GRANDWOOD RANCH
LETTER OF INTENT
PRELIMINARY PLAN

DEVIATION REQUEST AND DECISION FORM

Deviation No. 3 (4-15-2020): A deviation from the standards of or in Sections **2.3.4.B** and **2.3.7.C.4** of the Engineering Criteria Manual (ECM) is requested. The request is for intersection approach grades and “mid-block” centerline roadway grades exceeding the maximum allowable in the ECM. The details are described below. See attached Deviation No. 3 Exhibit by LSC and the attached plan and profile exhibit prepared by Matrix Design Group.

Deviation Exhibit 3
**Centerline
Roadway Grades**
Grandwood Ranch (LSC# 185020)

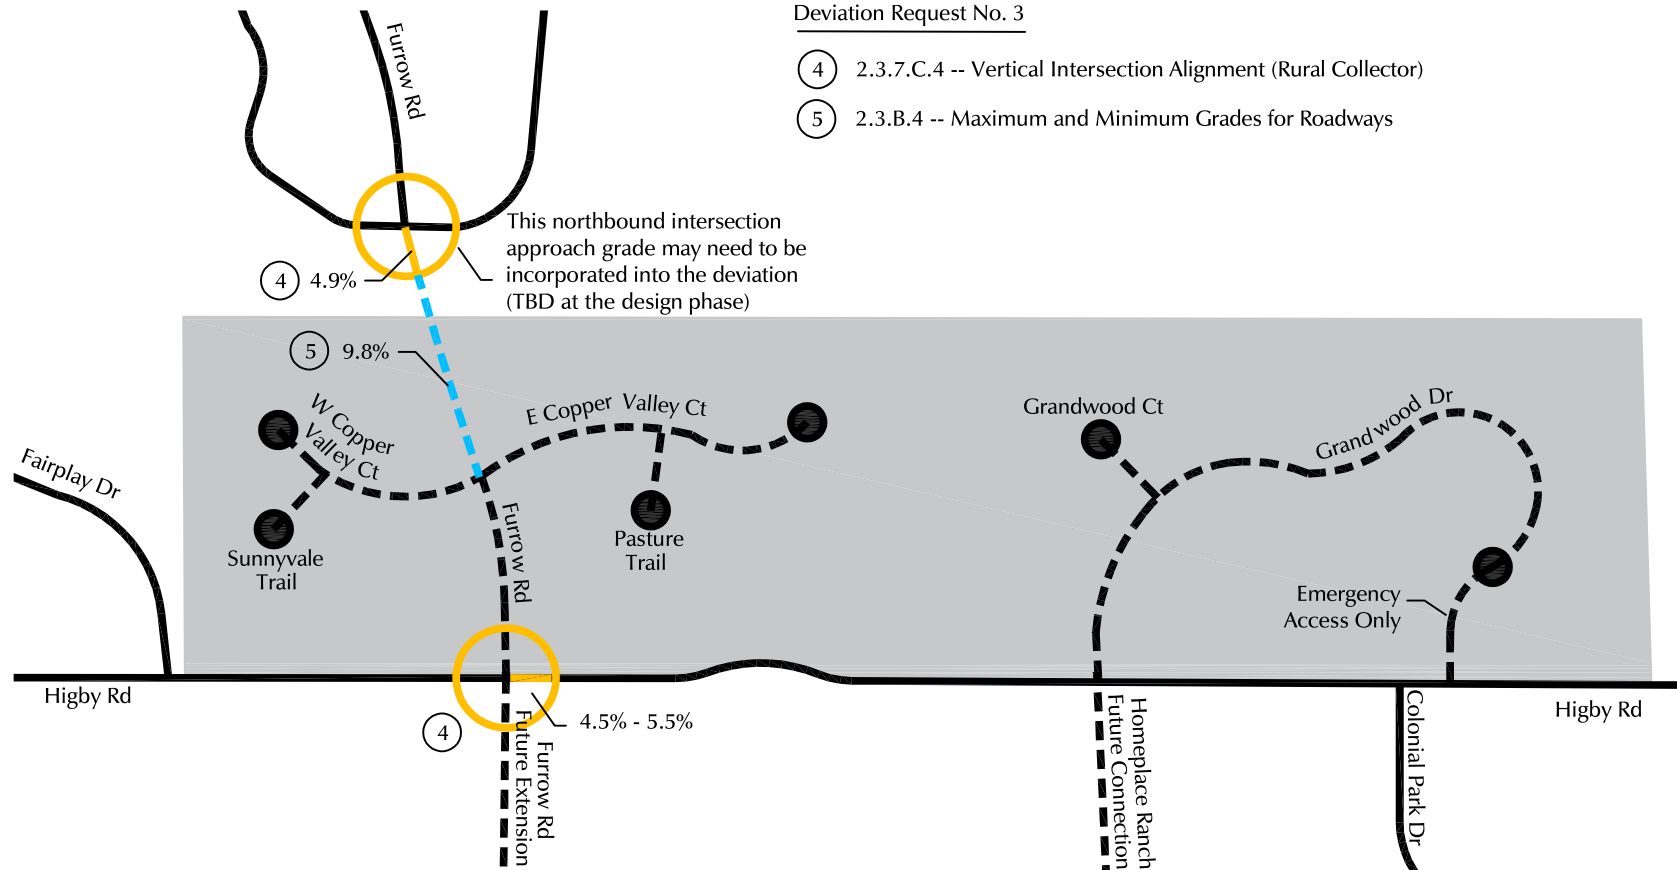
The design plans were prepared to minimize the intersection approach grades and roadway centerline grades. However, the natural grade is approximately 10% for about 900 to 1,000 feet south of Minglewood Trail. The change in elevation between the current terminus of Furrow Road (at Lamplight) and Higby Road and the horizontal distance between these two locations requires a deviation to the centerline roadway grade.

- North of the intersection (between the intersections of Copper Valley Court and Minglewood Tr.), the centerline roadway grade is proposed to be 9.8%

- The proposed westbound approach to the Higby Road/Furrow Road intersection is about 6.5 percent
- West of the proposed intersection, the grades moderate for the eastbound intersection approach.

The proposed "mid-block" centerline roadway grade north of the intersection (between the intersections of Copper Valley Court and Minglewood Trail) would exceed the ECM maximum. The centerline roadway grade is proposed to be 9.8%. The ECM standard for Rural Collectors is 8% maximum (10% maximum grade permitted at the discretion of the ECM Administrator). The proposed section of 9.8% grade would exceed the 8% standard by 1.8%. The proposed 9.8% meets (by 0.2%) the allowable maximum grade permitted with ECM Administrator approval (10%). See the attached deviation exhibit and the attached plan and profile exhibit prepared by Matrix Design Group.

GRANDWOOD RANCH
DEVIATION REQUEST EXHIBIT

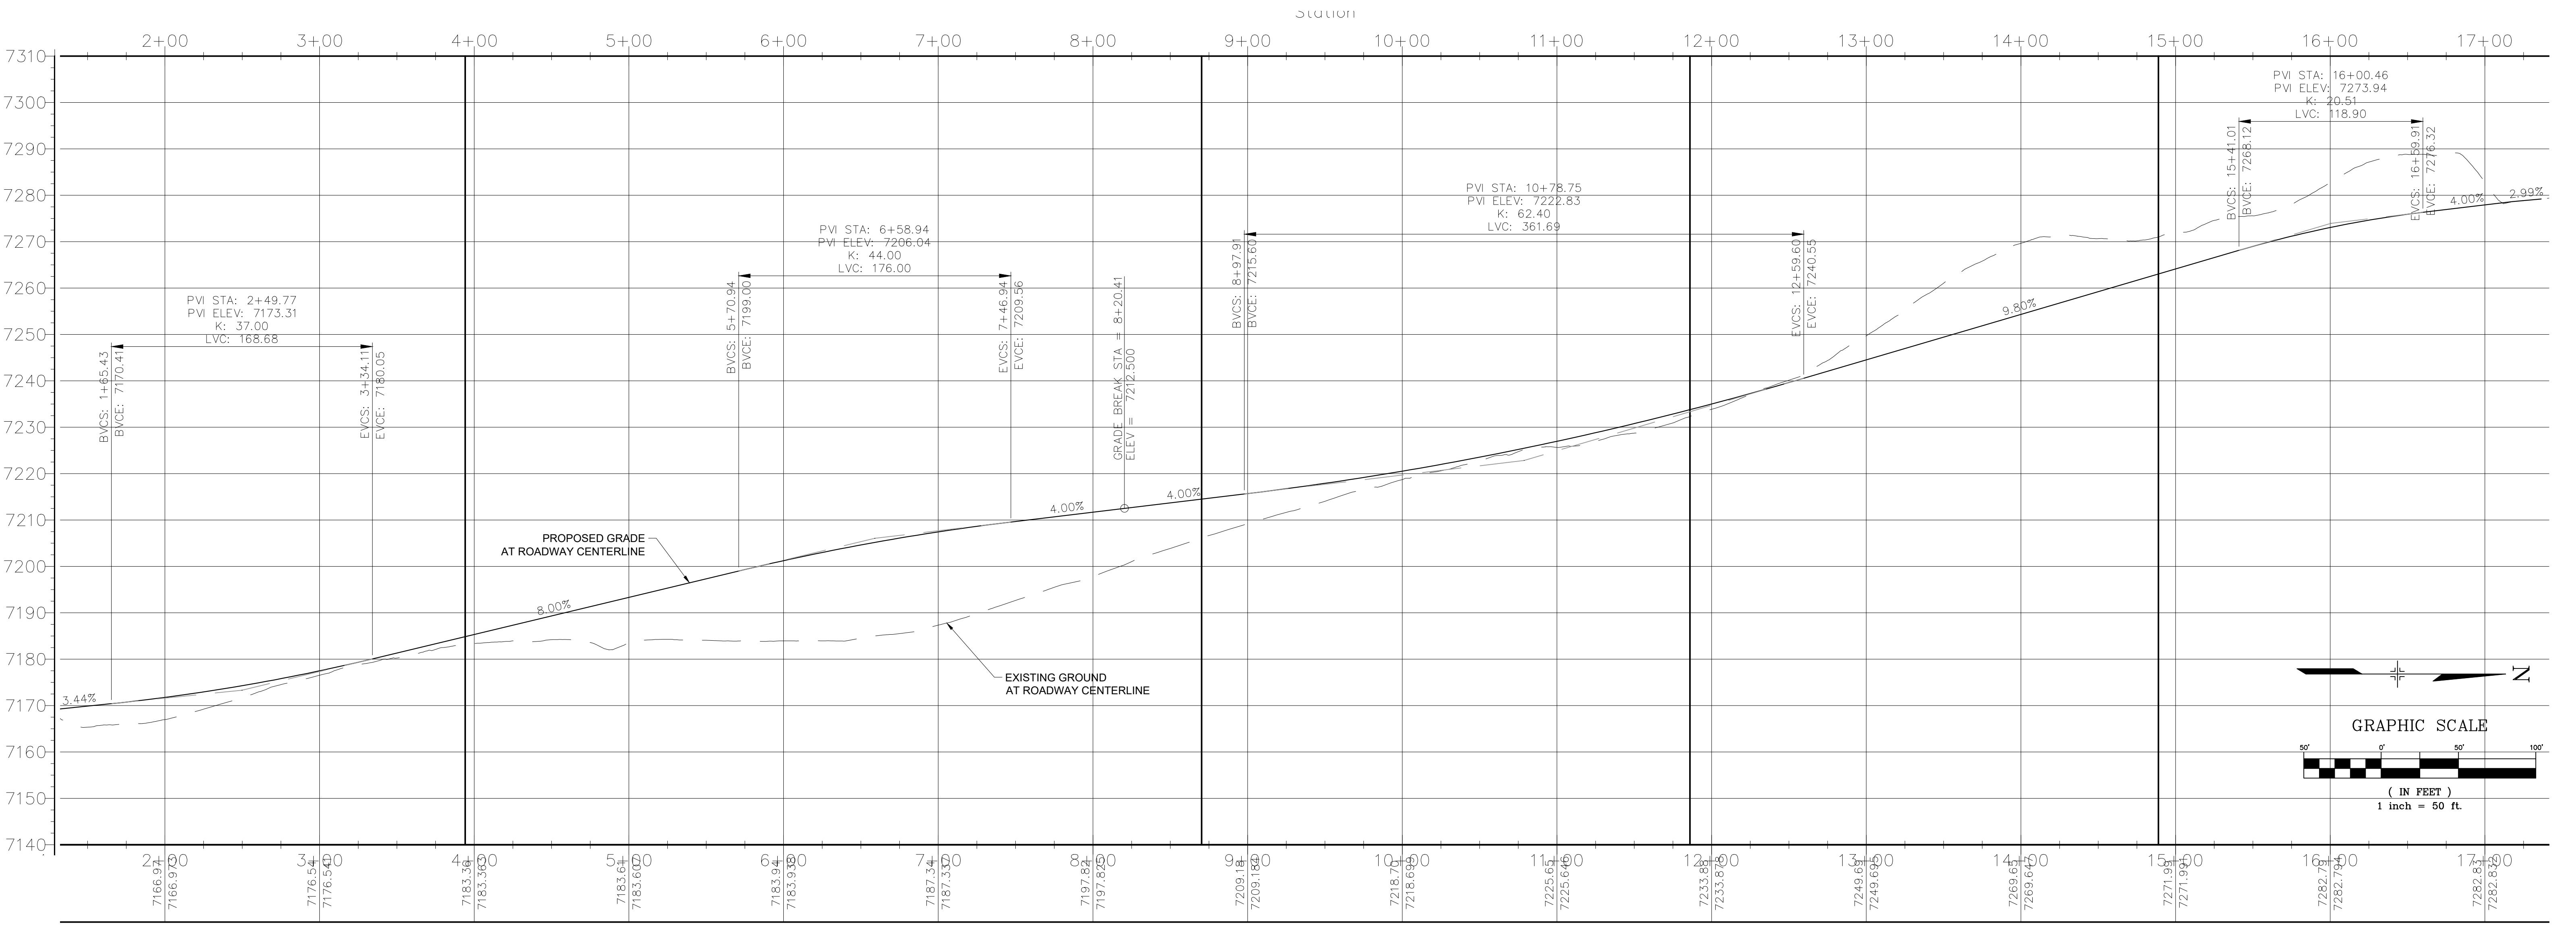
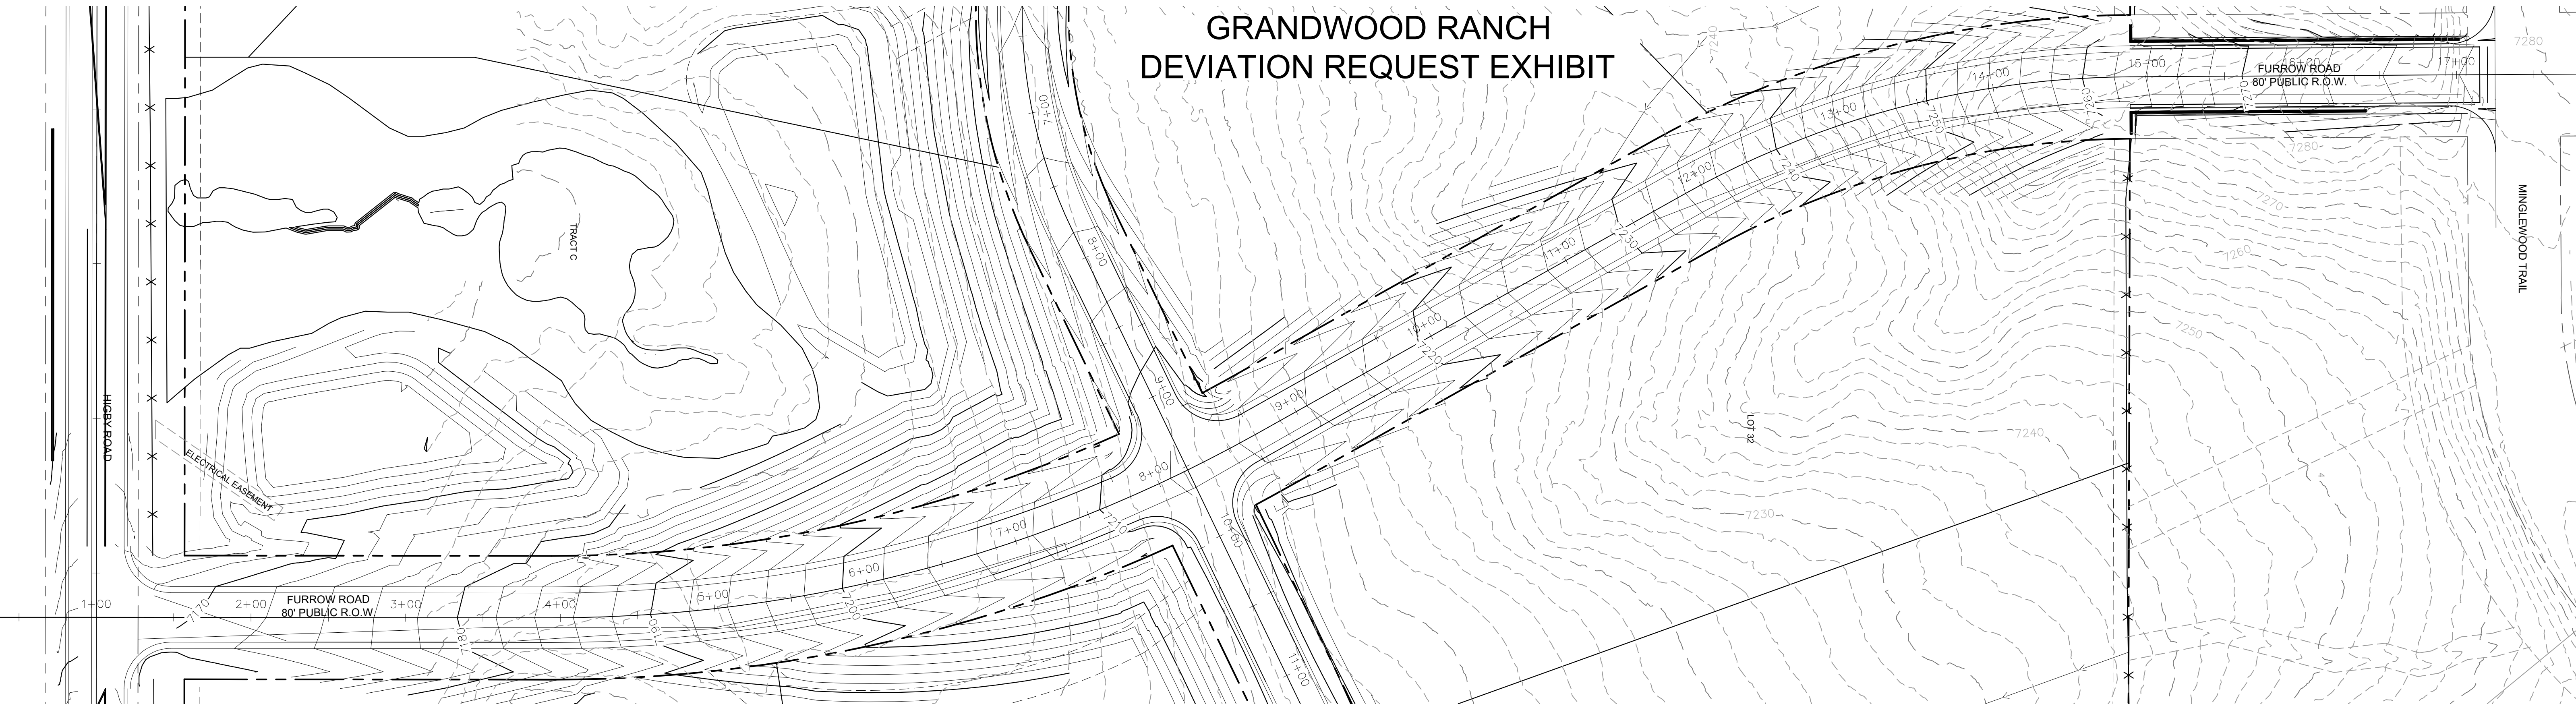
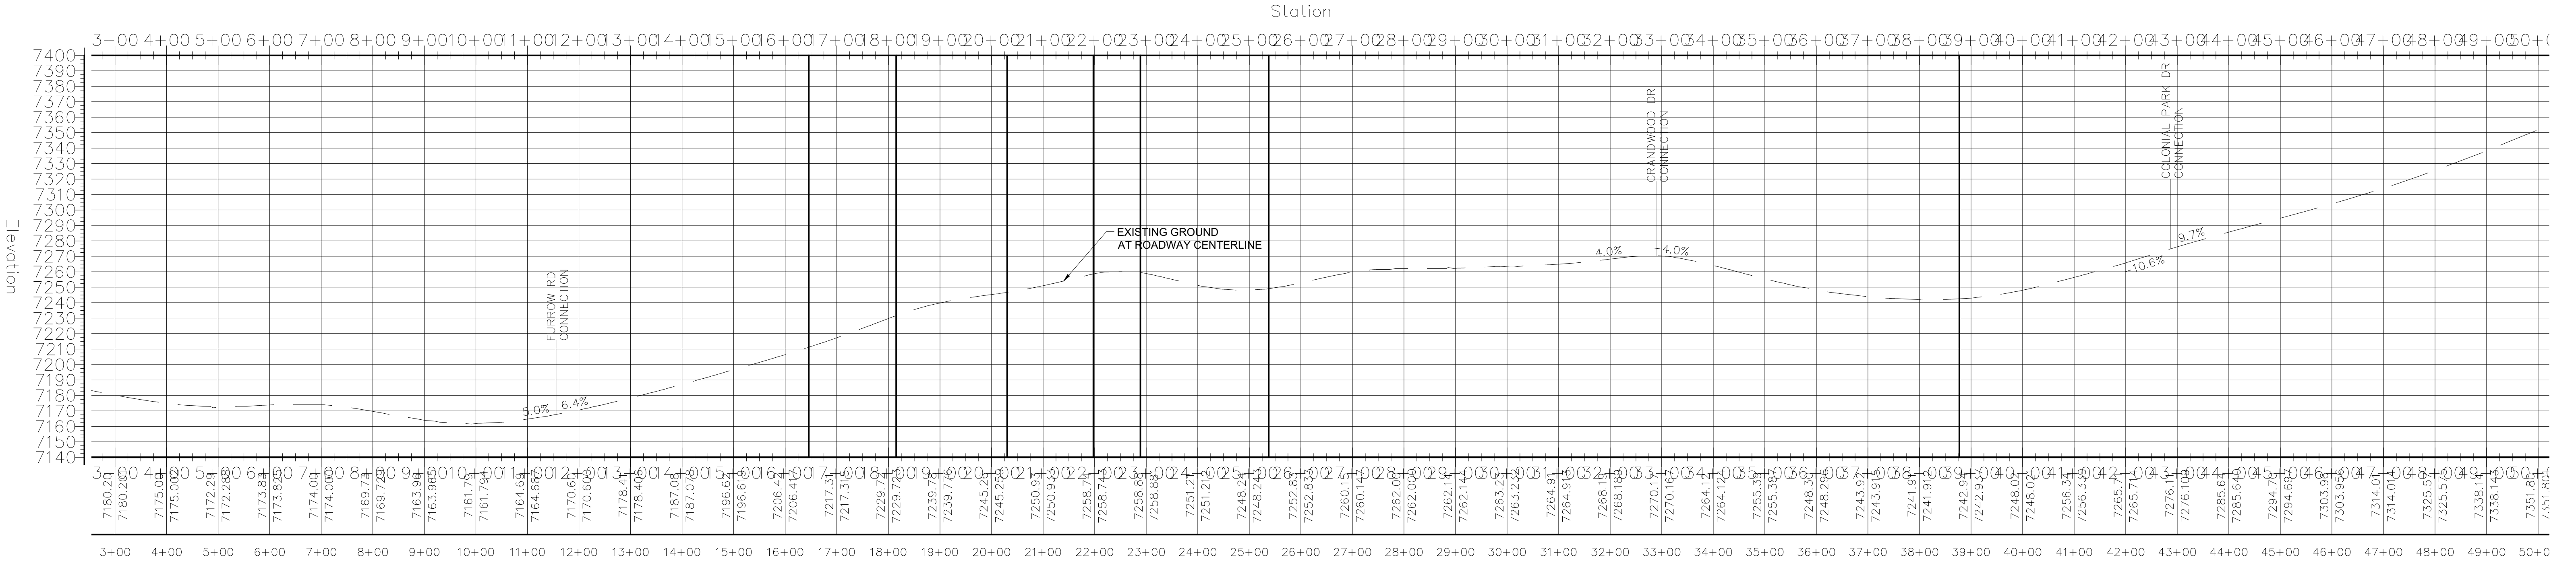
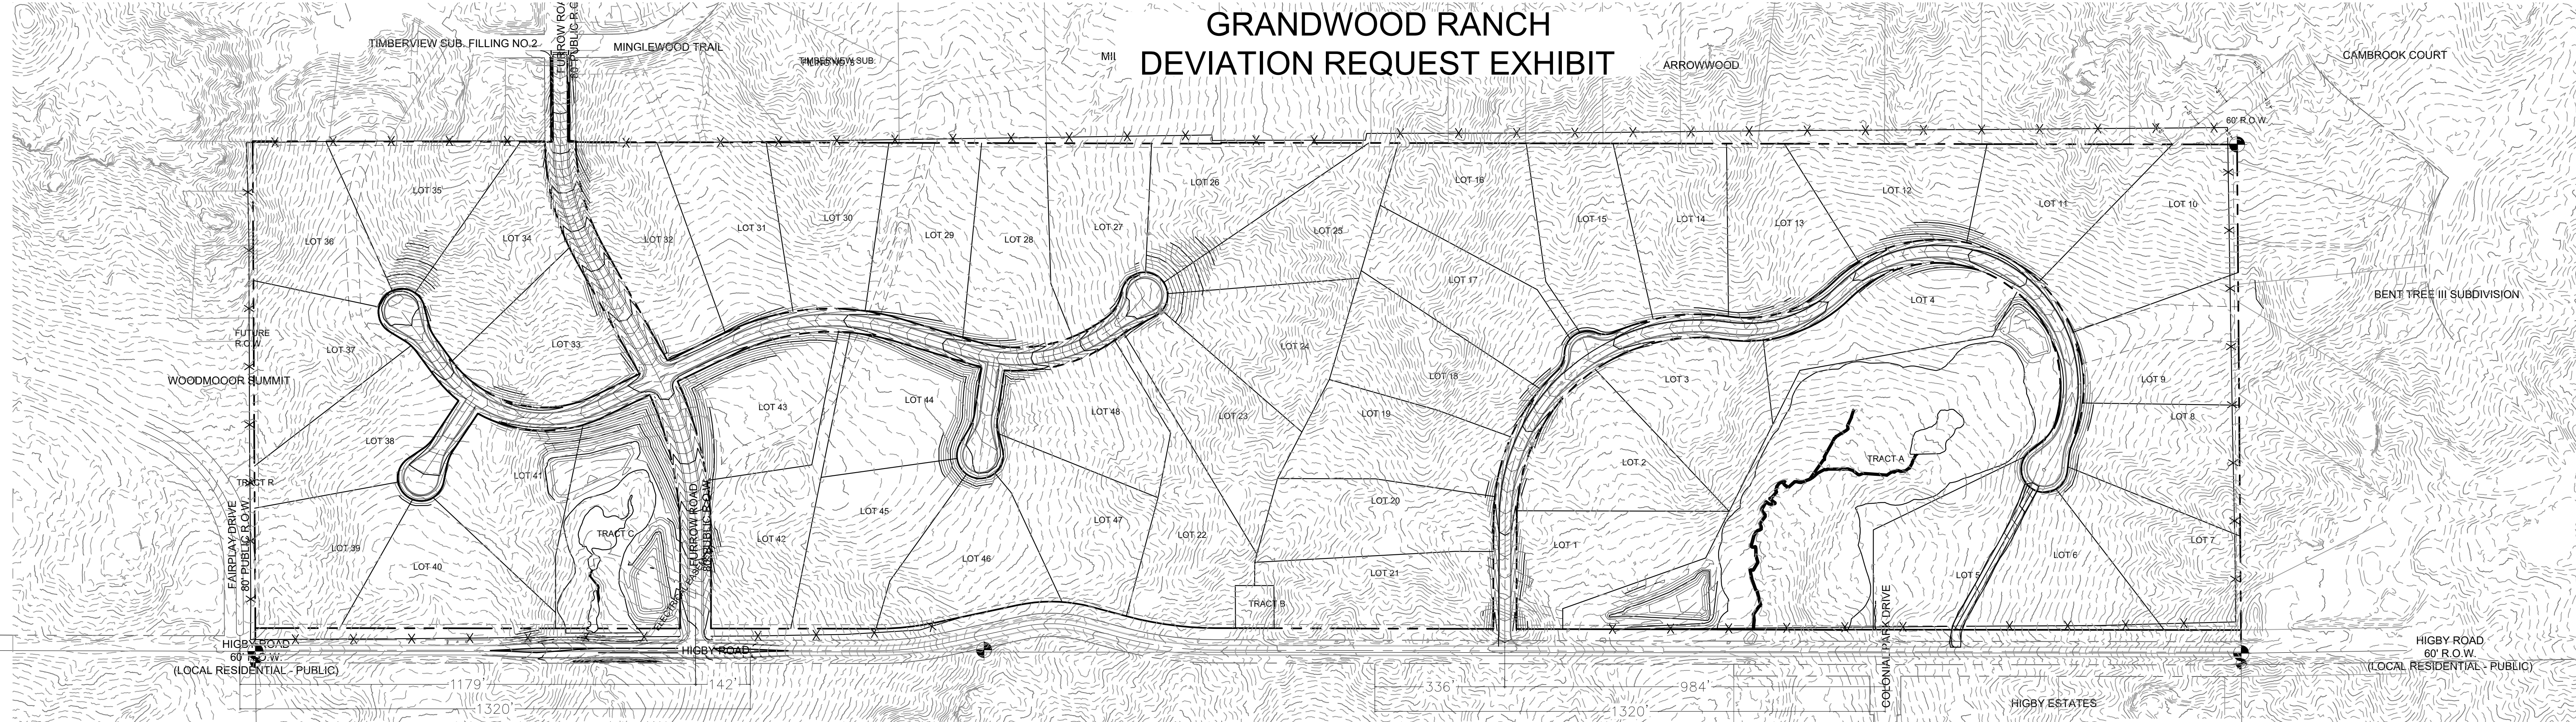
The design plans were prepared to minimize the intersection approach grades and roadway centerline grades. However, the natural grade is approximately 10% for about 900 to 1,000 feet south of Minglewood Trail. Given the change in elevation between the current terminus of Furrow Road (at Minglewood/Lamplight) and Higby Road and the horizontal distance between these two locations, a deviation to the centerline roadway grade is needed in order to meet the intersection grade standard at the proposed Furrow Road/Copper Valley Court intersection. The proposed 9.8% meets (by 0.2%) the allowable maximum grade permitted with ECM Administrator approval (10%).
